**RE: CITY EAST ZONE SUBSTATION PROJECT APPLICATION 2A(i)
20-26 O'CONNELL STREET AND 33-35 BLIGH STREET, SYDNEY**

**RE: CITY EAST ZONE SUBSTATION PROJECT APPLICATION 2A(i)
20-26 O'CONNELL STREET AND 33-35 BLIGH STREET, SYDNEY**

We act on behalf of the Lowy Institute of International Policy located in the former heritage listed NSW Club Building at 31 Bligh Street, Sydney. We are writing this submission as an objection to the current major project application known as the City East Substation Project Application 2A(i) lodged by Energy Australia with the Department of Planning.

Figure 1- Sydney CityGrid Project location plan

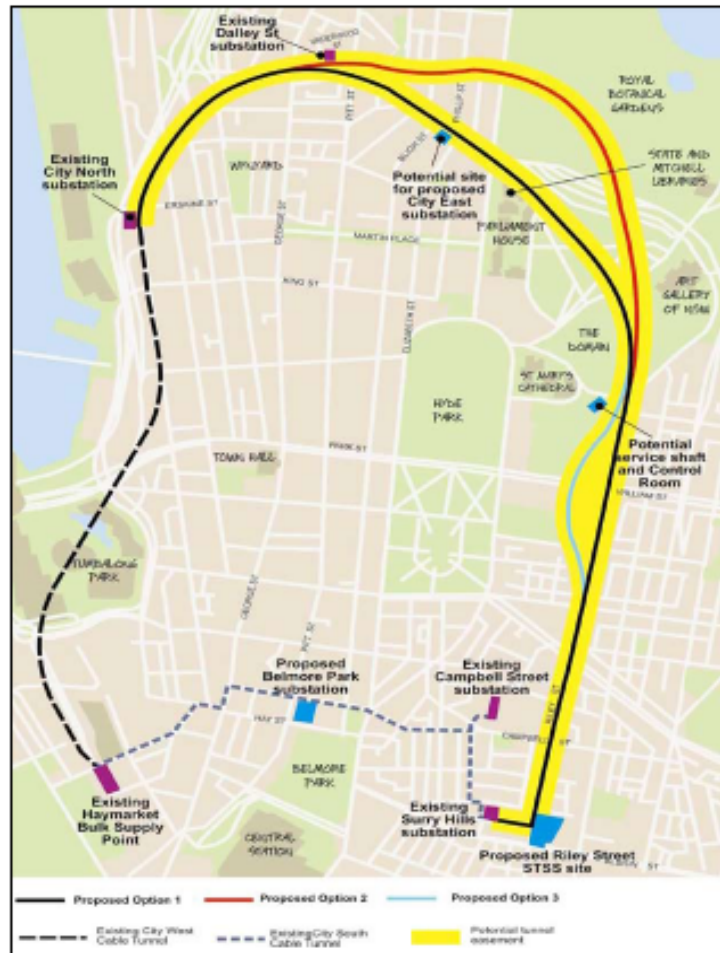
The Concept Plan approval did not specifically identify that 33-35 Bligh Street would be the site for the new City East Substation. Figure 1 below is an extract of Concept Plan and illustrates a *"potential site for proposed City East substation"* being adjacent to Bent Street and located between Phillip and Bligh Street immediately adjoining the proposed alignment of City East Cable Tunnel (CECT) easement (Option 1).

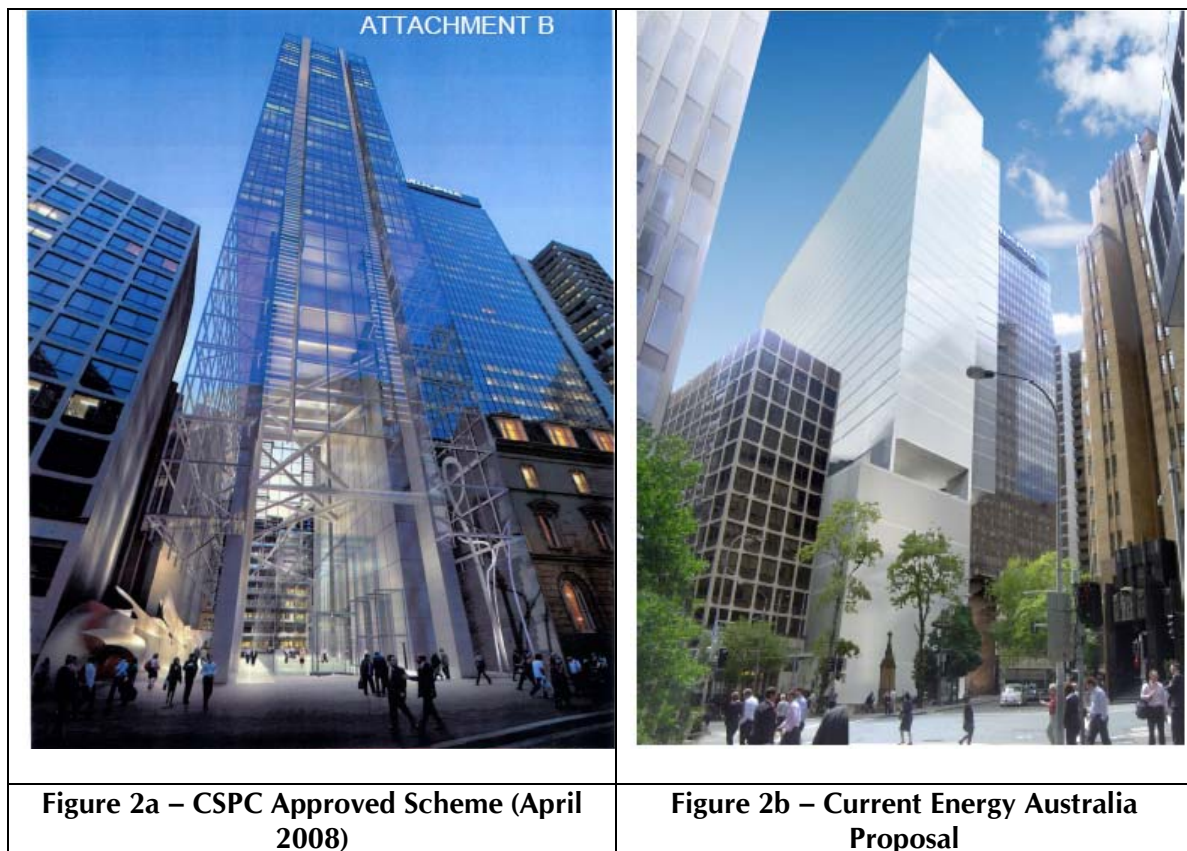
One of the key components of the proposed building envelope on the site is the proposal to establish 5 transformers at ground level with vehicle access from O'Connell Street. The Energy Australia proposal includes the design of these 5 transformers in one line extending from the O'Connell Street frontage to the Bligh Street frontage of the site as illustrated in the extract from the application in Figure 3 below.

Despite raising our concerns with respect to the design of the substation with Energy Australia in July this year the application has been lodged for assessment with no attempt to respond to the planning constraints of the site.

We request that prior to any further assessment of the current application or any consideration of a building envelope on the site that Energy Australia provide an alternate design solution that responds more appropriately to the significant planning constraints of the site.
